SRPP ADDENDUM REPORT DA-2021/957 (PPSSTH-99)

1. EXECUTIVE SUMMARY

Figure 3: Existing view corridor from Avante towards the site

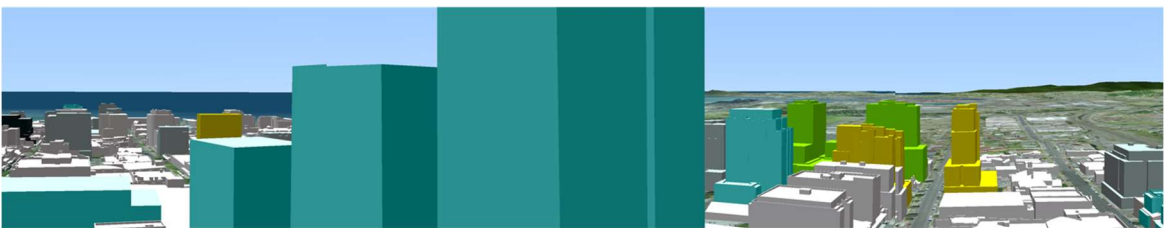
The Panel requested Council confirm whether these images generally correlated with Council's expectations of view impacts from the proposal on Avante residents. In that regard, Figure 3 and Figure 4 below contain screen captures from Council's 3D modelling software indicating the before and after view from Avante looking towards the site. These are broadly consistent with that illustrated in the objector's submission. Also included below are two figures from the assessment report illustrating broader views available from the Avante building. Figure 5 contains a typical floor plan from the Avante building that was used in the view sharing assessment in the Council report. It is noted that views from centre units are more restricted in enjoying wider views towards the west and east.

The view impact analysis contained in the assessment report addressing the Tenacity planning principle remains applicable.
